SUBJECT: FERMI-2 - AMENDMENT NO. 77 TO FACILITY OPERATING LICENSE NO. NPF-43
(TAC NO. 81232)

The amendment revises the Pressure Temperature Curves in the TS in accordance with Regulatory Guide 1.99, Revision 2.

SAFETY EVALUATION BY THE OFFICE OF NUCLEAR REACTOR REGULATION
RELATED TO AMENDMENT NO. 77 TO FACILITY OPERATING LICENSE NO. NPF-43

FIGURE 3.4.6.1-1

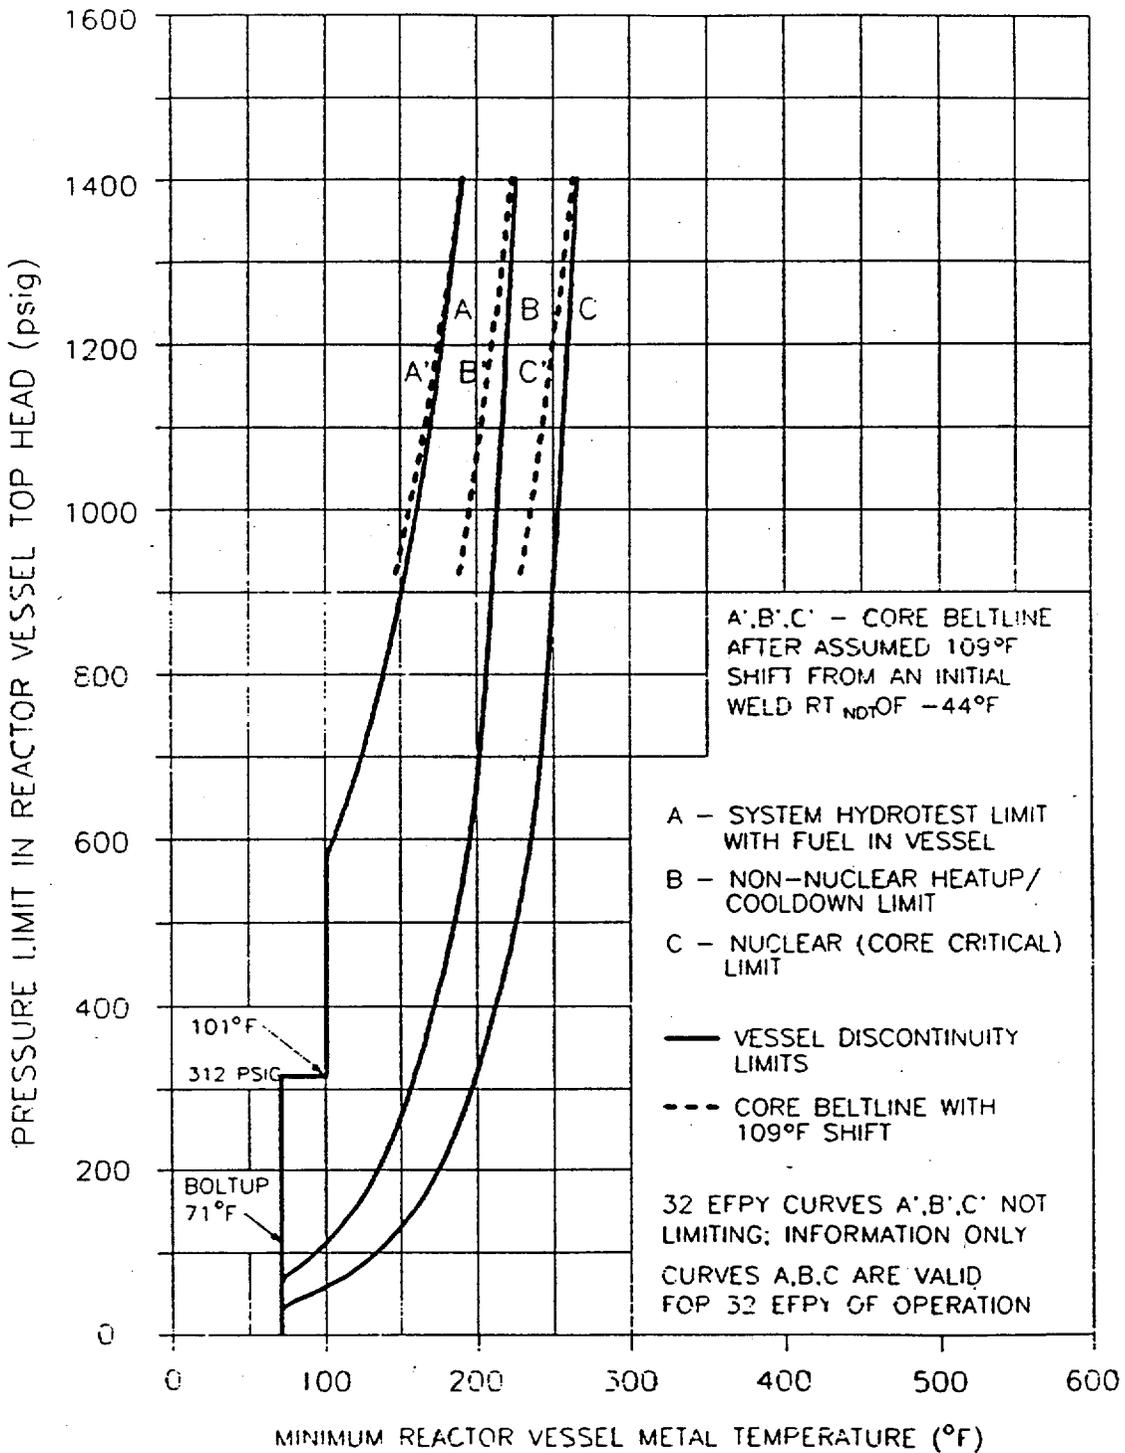
The licensee used the method in RG 1.99, Rev. 2, to calculate an ART of $65.3^{\circ}F$ at 32 EFPY at $1/4T$ for the same limiting weld metal. The staff judges that the licensee's ART $65.3^{\circ}F$ is more conservative than the staff's ART of $65.2^{\circ}F$, and it is acceptable. Substituting the ART of $65.2^{\circ}F$ into equations in SRP 5.3.2, the staff verified that the proposed P/T limits for heatup, cooldown, and hydrotest meet the beltline material requirements in Appendix G of 10 CFR Part 50.

The staff concludes that the proposed P/T limits for the reactor coolant system for heatup, cooldown, leak test, and criticality are valid through 32 EFPY because the limits conform to the requirements of Appendices G and H of 10 CFR Part 50. The proposed P/T limits also satisfy Generic Letter 88-11 because the method in RG 1.99, Rev. 2 was used to calculate the ART. Therefore, the proposed P/T limits may be incorporated into the Fermi-2 Technical Specifications.

3.4.6.1 The reactor coolant system temperature and pressure shall be limited in accordance with the limit lines shown on Figure 3.4.6.1-1 (1) Curve A for hydrostatic or leak testing; (2) Curve B for heatup by non-nuclear means, cooldown following a nuclear shutdown and low power PHYSICS TESTS; and (3) Curve C for operations with a critical core other than low power PHYSICS TESTS, with:
